From: Simon Davis [REDACTED]
Sent: 24 March 2017 10:18
To: Developer Services
Subject: The Gatehouse, Lidsey Road, ADC Ref: AL/9/17/DOC, Your Ref: PLAN-017219

In reference to your email dated 24th February 2017, and 2 attachments in regard the outstanding condition numbers 4 & 9, we would respond as follows –

project	Residential development The Gatehouse, Lidsey Road. Woodgate		
detail	site layout plan		
drawn	sgf	checked	
date	09-15	status	Const.
a1 scale	1:100	a3 scale	1:200
			8590 10 B

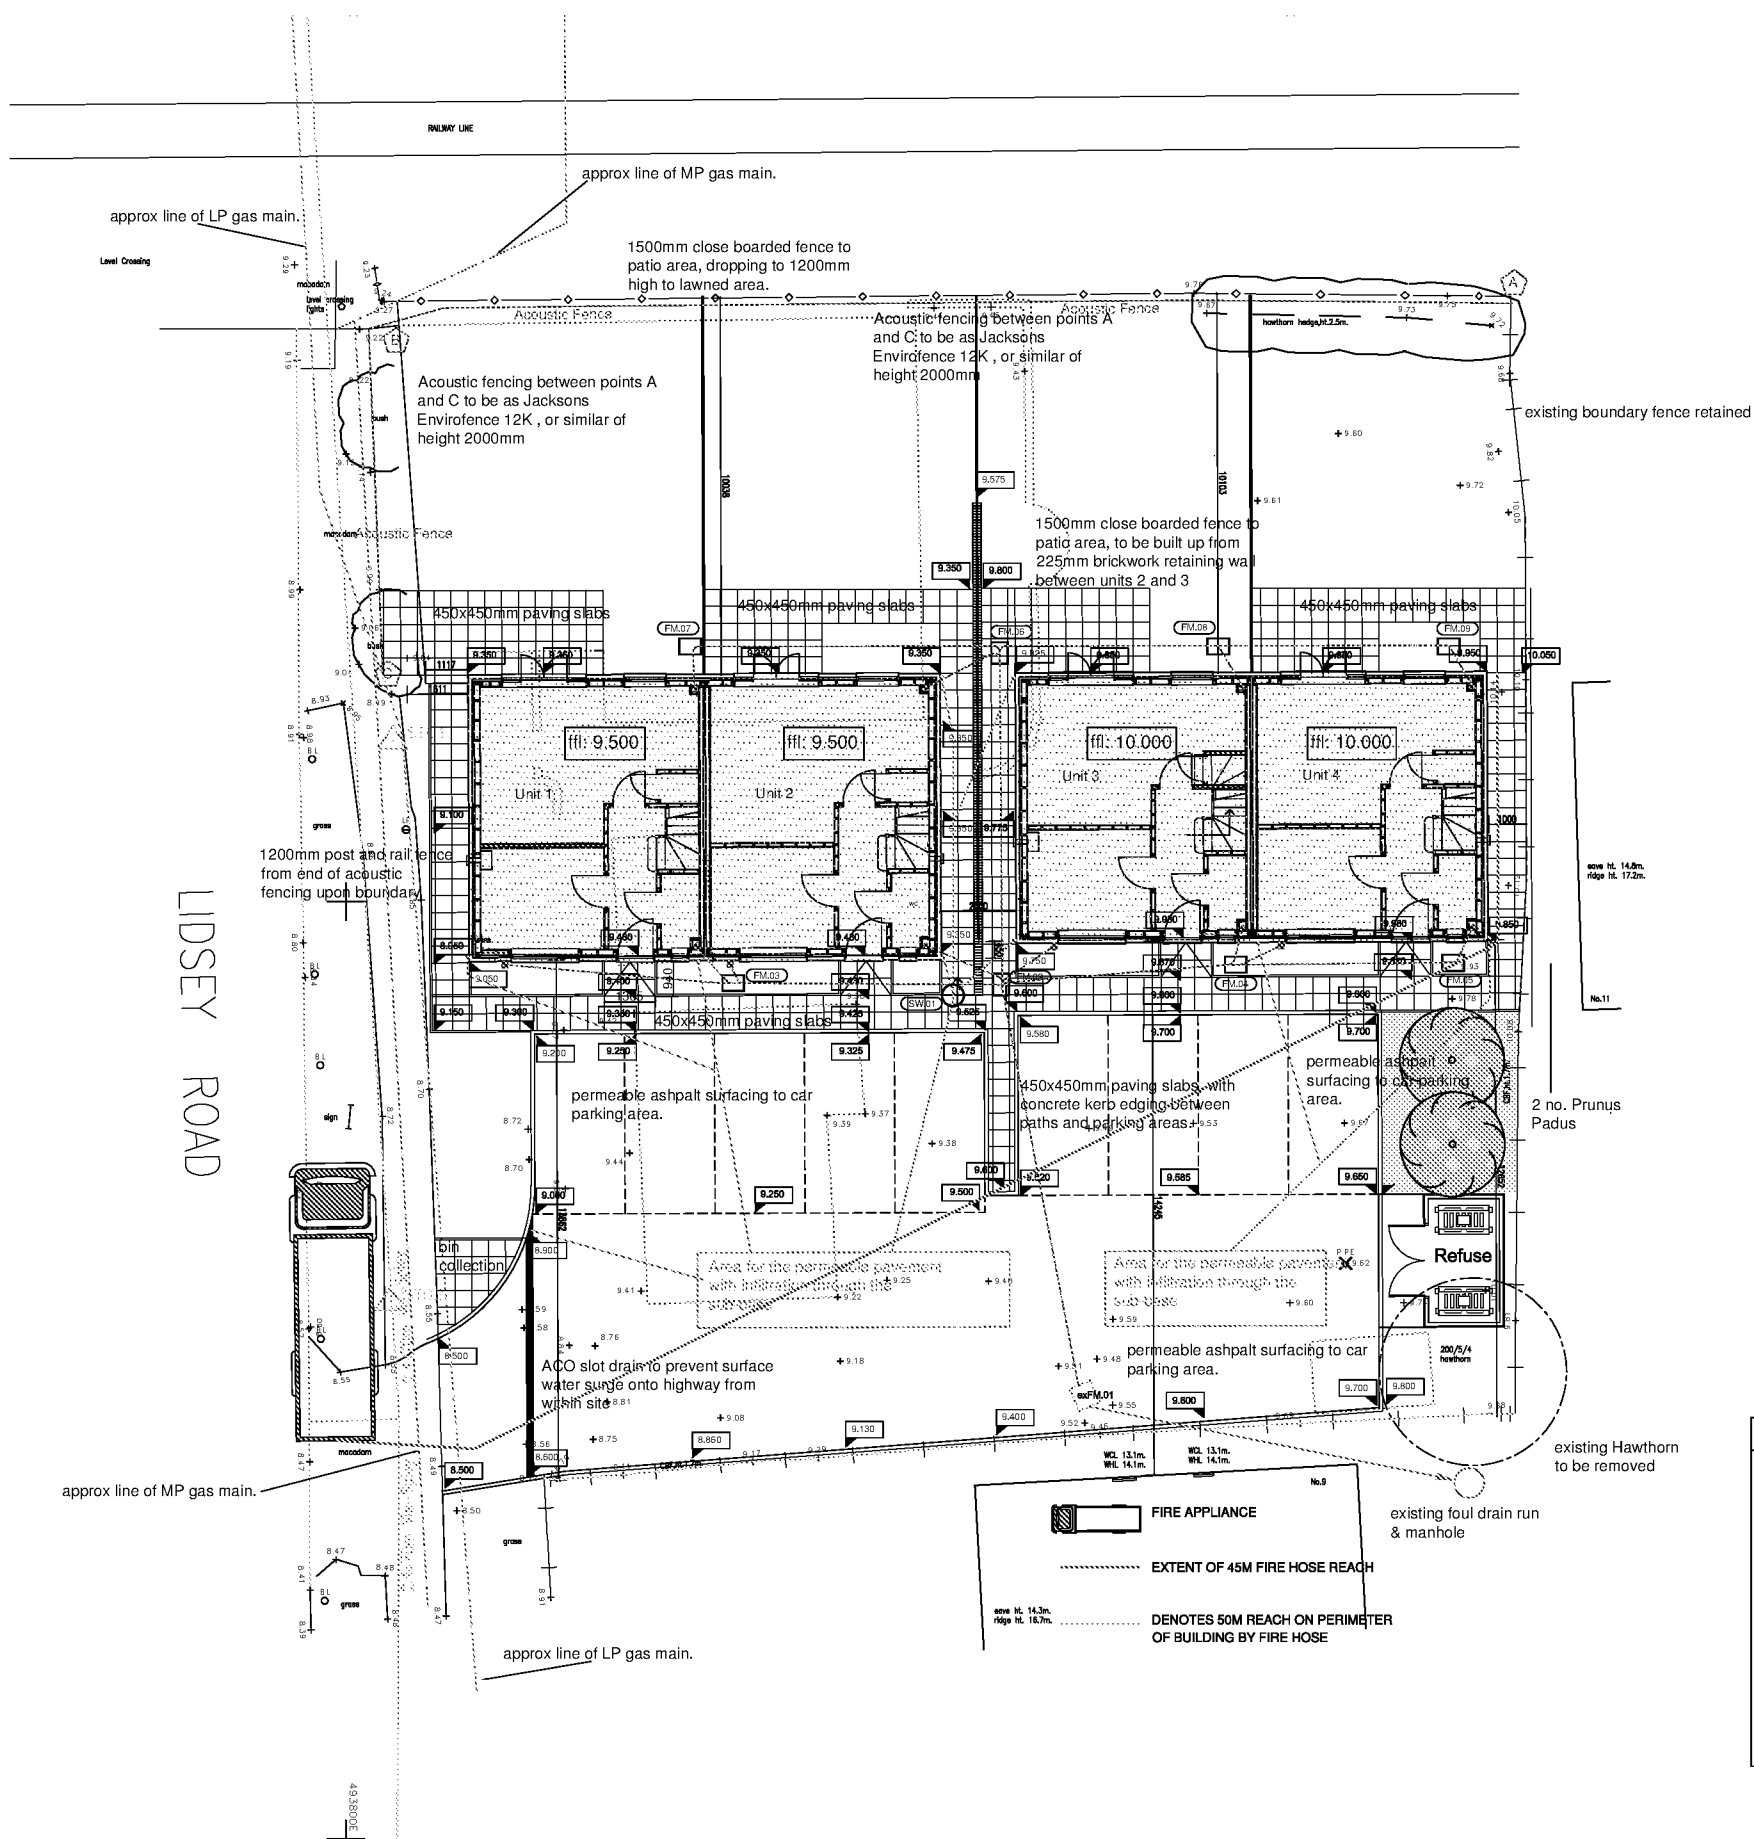
I think I see the problem. We have Drawing 8590-11B on our system which states that:

"Connection pipe that transmits the run-off at the predevelopment rate into the existing sewer. An overflow connection with the top of the permeable pavement sub-base can direct a separate over flow of run-off towards the sewer if the soakaway fills up during an event of greater magnitude than the 1 in 100 year 6 hour + climate change at 30% rainfall event."

I assume then that 8590-10-B should replace 8590-11B? Please confirm.

Condition 9 – We attach our drawing number 8590-10B, which had previously been issued, this showing the amendment of the SW to not discharge into the foul drain, so we are somewhat surprised this has not been discharged. It is not the intention to discharge any SW into the foul and the drawing confirms this so we hope this can be discharged immediately.

That is correct, the submitted drawing takes precedence as it is not intended in any way to have the surface water connect into the existing foul system,

Southern Water would have no objections to discharge condition 9 relating to foul drainage. The acceptable drainage strategy is as shown on drwg Site Layout Plan 8590 10 Rev B. An approval for the connection to the public foul sewer should be obtained under Section 106 of the Water Industry Act. The design of drainage should ensure that no surface water run off, groundwater or land drainage is to enter public sewers.

2. Potential SuDS scheme options layout

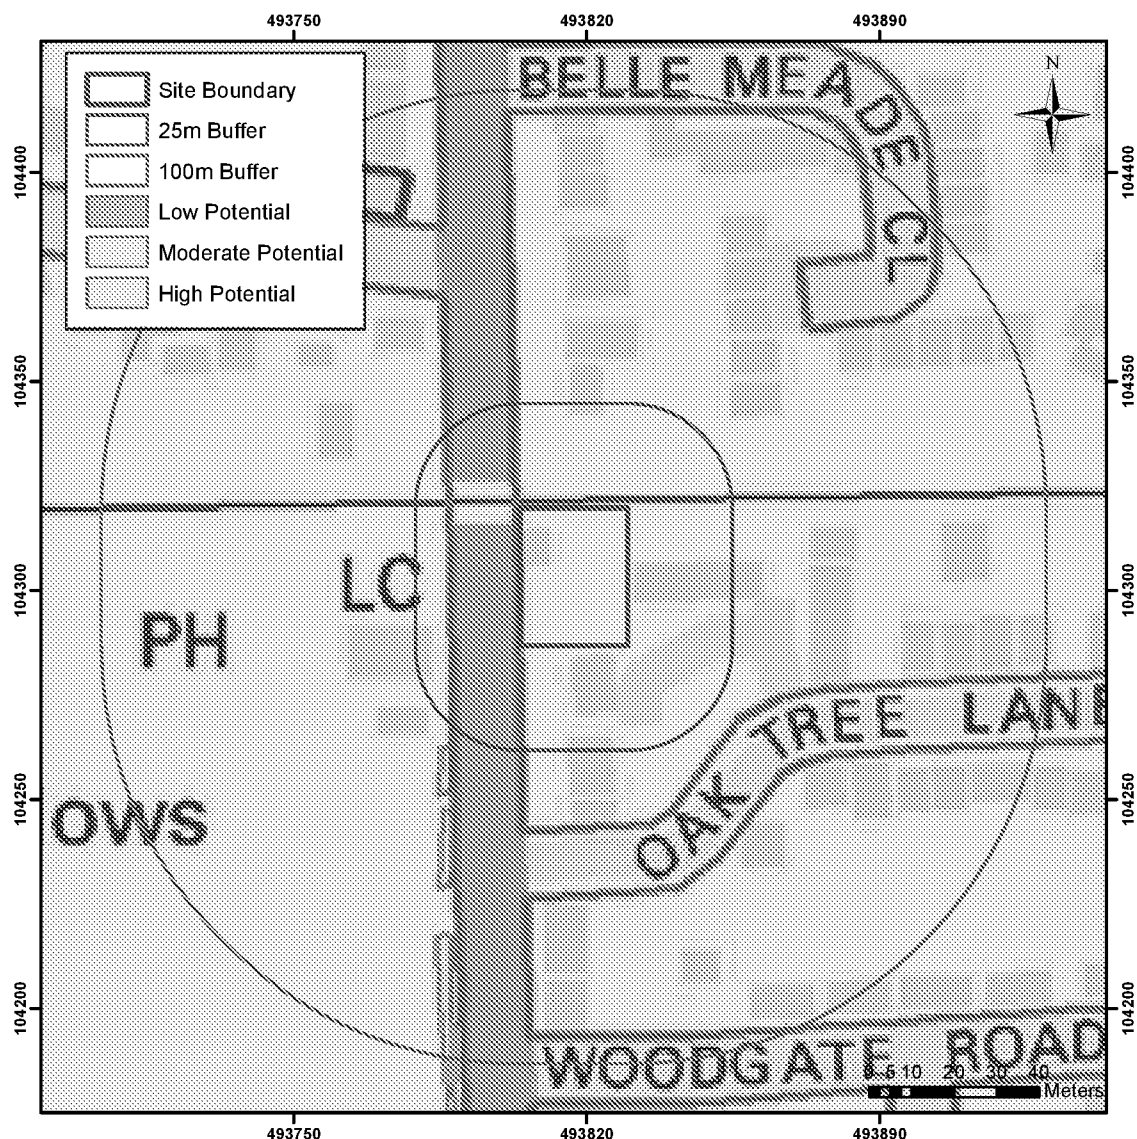
"Proposal for permeable paving with geo-cellular crate sub-base of 30 sq m area and 0.52m depth subbase/crates. For type B systems it is stated that maximum depth would be 0.42m for sub-base/crates. The storage volume for the 1 in 100 year storm event plus 30% climate change allowance would be provided by increasing the area to 42 sq m with 0.42m sub-base/crates at 95% voids. The half drain time would exceed 24 hours but not by a large amount.

The issue with having an overflow to the existing sewer is that we have no record of any public surface water sewer to discharge to and no further information on private sewers. If this sewer discharges to the foul network then we would not allow any surface water flows to be discharged to this system, even from an overflow. All existing surface water flows to a foul system should be removed. Please provide evidence that shows the existing sewer does not flow to a foul system, otherwise we will definitely require full infiltration with the increase in storage as proposed above".

Permeable paving is intended for the Site to provide infiltration within the limitations of the Site. A Type B system for Partial Infiltration was originally proposed, however, as stated by the Arun District Council Drainage & Coastal Engineer, there are no surface water sewers in the immediate area and discharge to a foul sewer or highway drain is likely to be unacceptable. As this is the case, full infiltration is required for the Site by the council.

Permeable paving with a geo-cellular crate sub-base and crates with a 95% void space is required for the Site, in order to accommodate the required attenuation volume. Permeable surfacing is already proposed for the car parking area and the driveway to the car parking area, but the patio has also been considered for this use. According to client provided plans and further confirmation from the client that patio areas could be used, these areas have a cover of 497 m².
